14399
8 August 2014

SUBMISSION ON HERRING ROAD URBAN ACTIVATION PRECINCT

This submission has been prepared by JBA on behalf of Macquarie University (MQU) in response to the public exhibition of the *Herring Road, Macquarie Park – Urban Activation Precinct* (the UAP). We thank the NSW Department of Planning and Environment (the Department) for the opportunity to prepare a submission in response to the exhibition of the document.

Figure 2 – View along University Avenue with UAP envisaged development on the Baptist Site dominating views from the public domain along University Avenue
Source: Cox Richardson

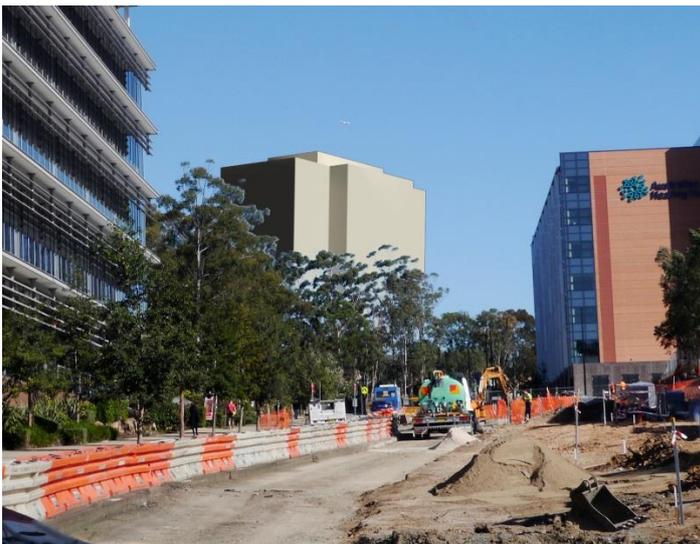
1. This part of the Baptist Site is not a gateway site, and the proposed height of 65m would represent an isolated area of higher density that is inconsistent with the scale of proposed development along Epping Road (45m) and development that will surround the site to the north, north-east and north-west (within the MQU campus) which does not form part of the UAP and have been consciously excluded for reasons of lack of proximity to Macquarie University Station.
2. This part of the Baptist Site only has a narrow frontage to Balaclava Road and no frontage to Epping Road, it is considered that heights such as those envisaged would be more appropriate along Epping Road.
3. The development of the scale proposed would terminate important view corridors along University Avenue and Macquarie Drive, as shown at **Figures 1 - 4**. Tall buildings in this location would also be

As shown at **Figure 2**, the proposed height controls on the Baptist site will result in a tall building at the end of the important University Avenue axis. The built form possible in the UAP controls will dominate this major campus road (the main vehicular link across the campus). Further, the University cannot control the architectural quality or outcome.

Any future development on the Balaclava Road frontage should incorporate significant setbacks from the street to retain the green gateway to the campus
